**UNITED  
TECHNOLOGIES  
CARRIER**

BULLETIN: CA-SB-19-C-71-53

## SERVICE BULLETIN

SUBJECT: R1 AND R2 RELAYS ON BARBER - COLMAN CONTROLS

Fig. 1

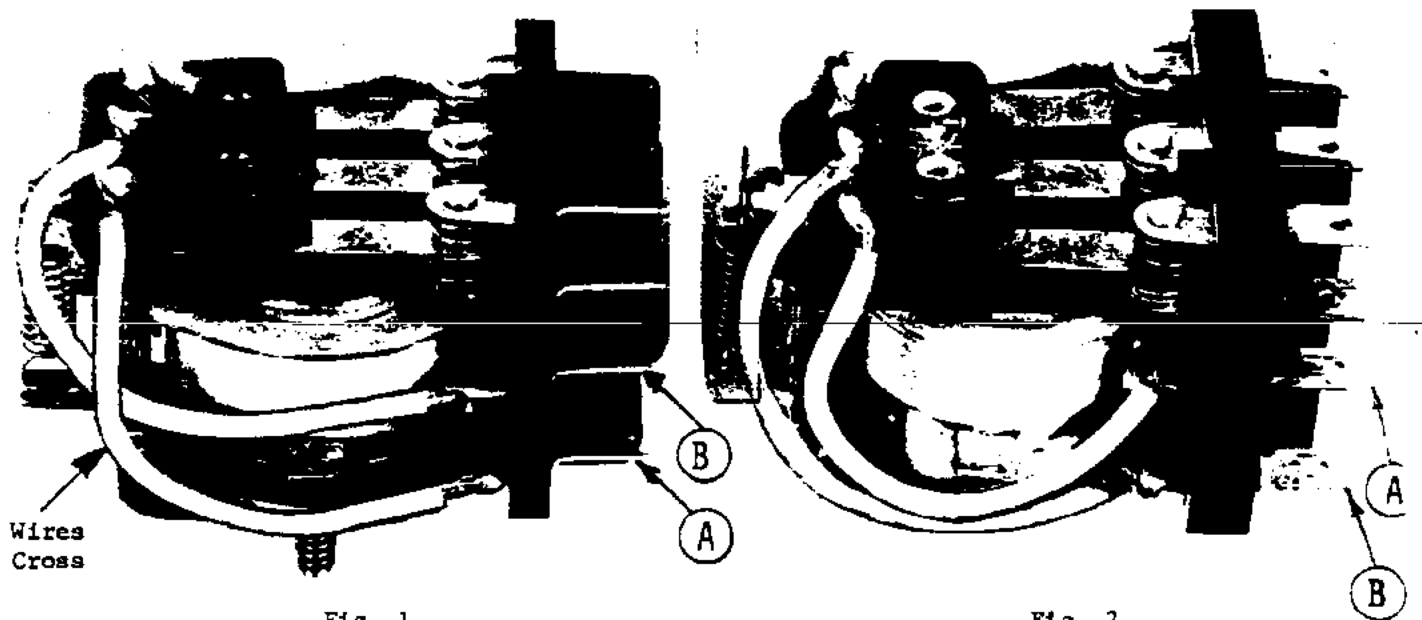
The configuration of the subject relays may vary from machine to machine, but the replacement relay, HN61ZL010, from Service Parts will always be as shown in Fig. 1.

When a relay is replaced, check the configuration of the wires from Terminals A and B back to the contacts. If the configuration is as shown in Fig. 1, no leads are to be reversed. If the configuration on the existing relay is as shown in Fig. 2, the incoming leads to Terminals A and B must be reversed on the replacement relay.
